TITLE: ZBA 06-25: 224 S. Craig Place

VILLAGE OF LOMBARD
INTER-DEPARTMENTAL REVIEW GROUP REPORT

ZBA 06-25; 224 S. Craig Place: The petitioner requests approval of the following actions on the subject property located within the R2 Single-Family Residence District:

Appendix A
Alternate Site Plan (if petition is denied)

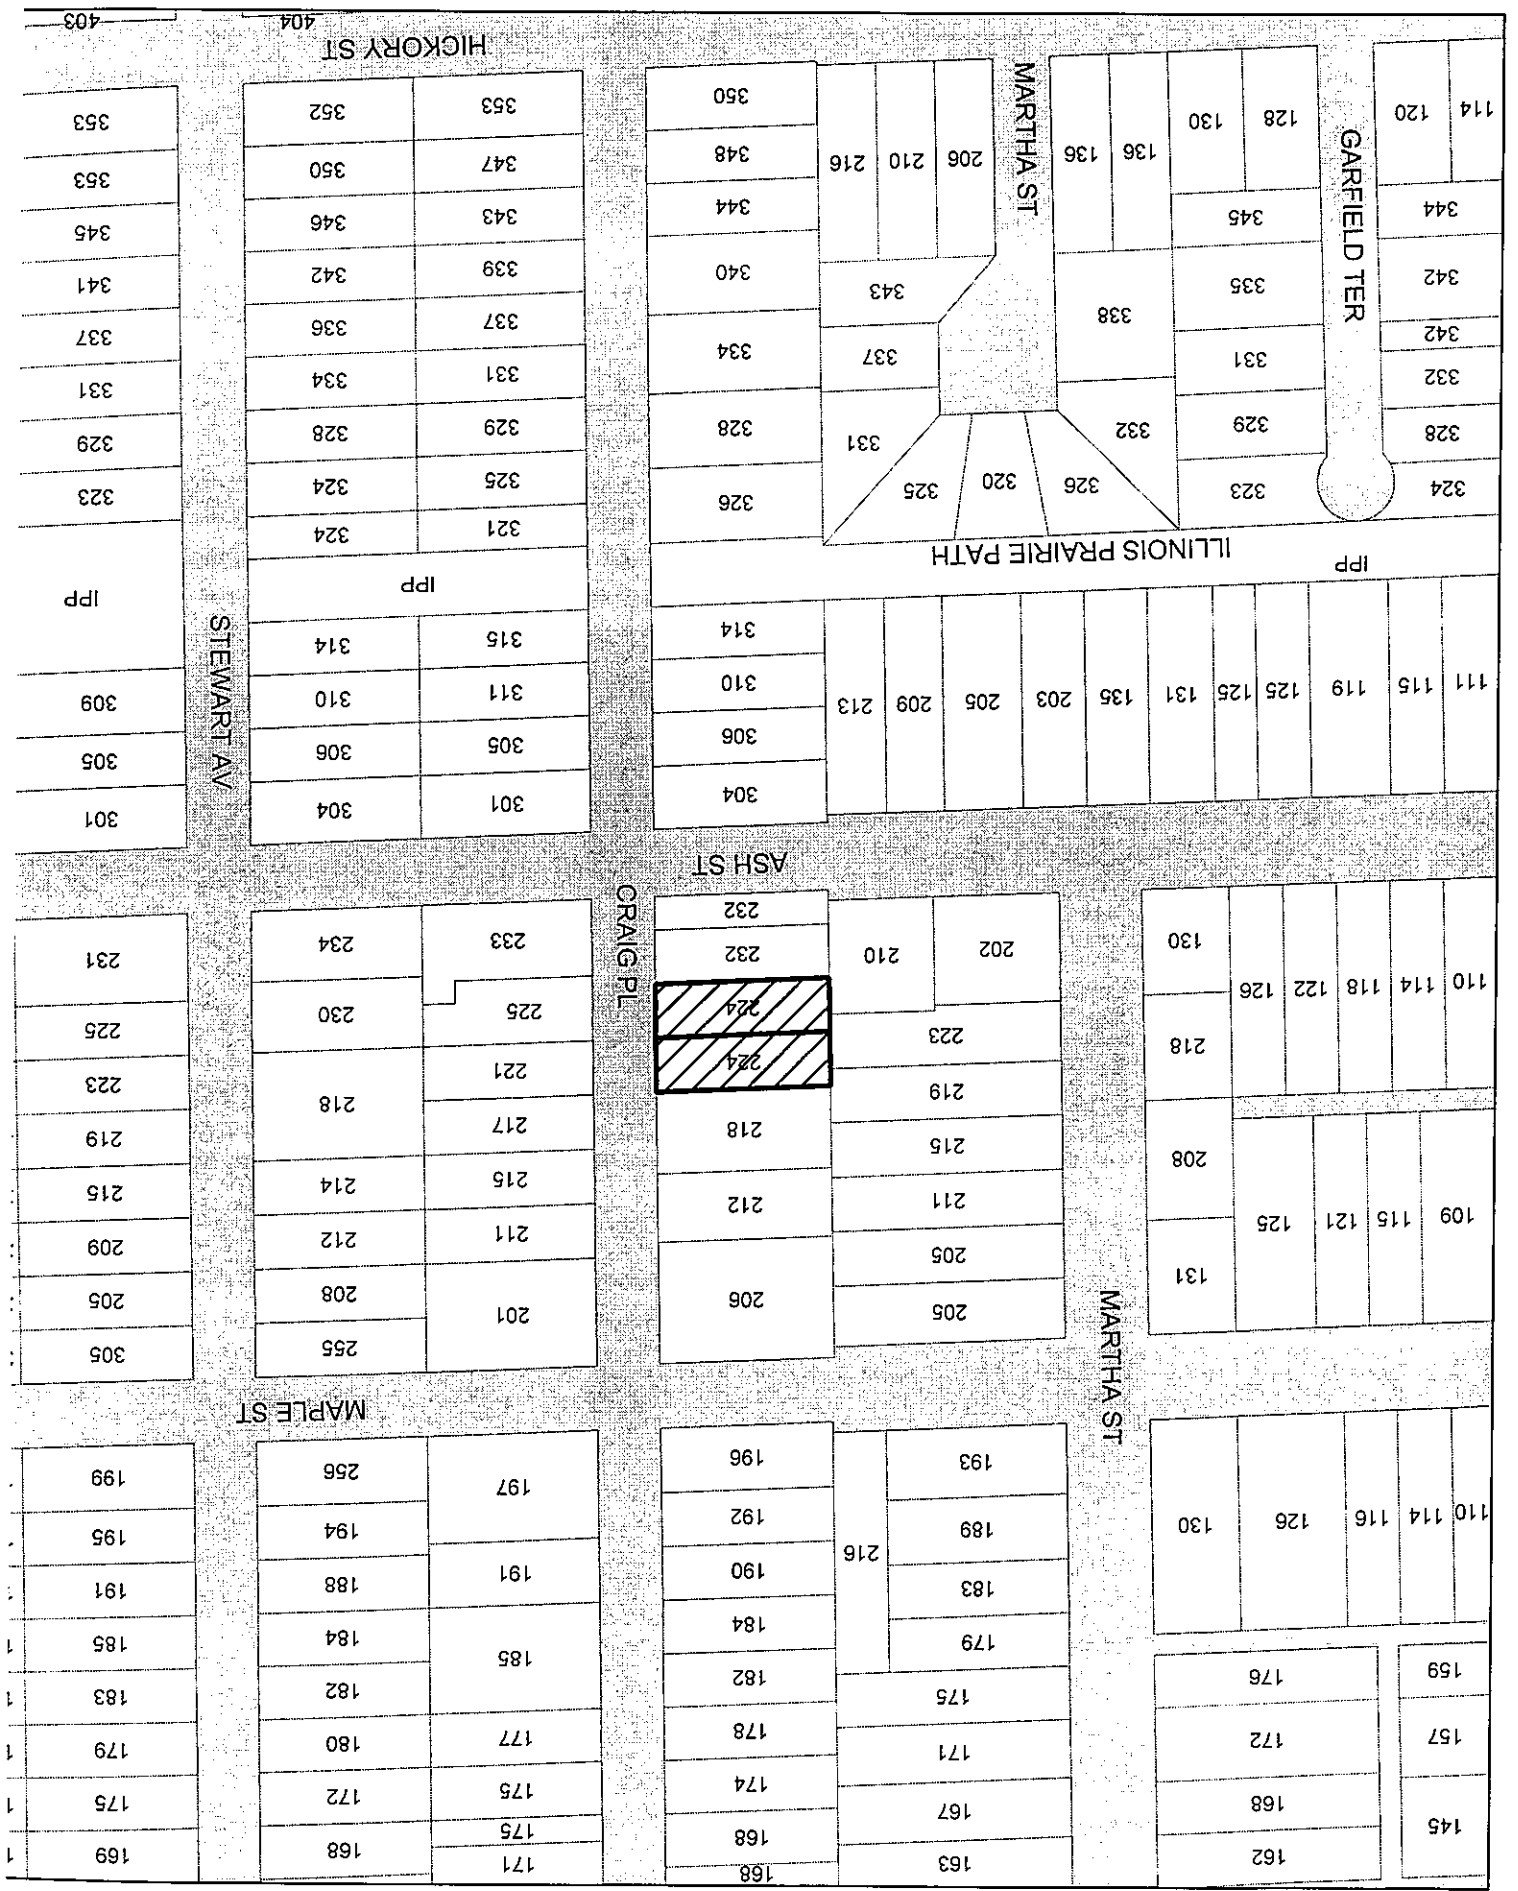
Mr. Ezerins concluded by stating that the porte-cochere was designed to accommodate a future ramp. He also explained that the permit plans shown in Appendix A of the staff report had only been submitted to allow them to get a building permit before the variations had been approved and to provide an option in the event the petition is denied.

In July of this year, the petitioner submitted a building permit application showing the proposed porte-cochere and deck encroachments into the interior side yards. Since that time, revised plans have been submitted that comply with all setback regulations to allow the addition and renovations to proceed in the event that this petition is denied. However, the petitioner would prefer to receive the requested variations to allow them to proceed with their original proposal.
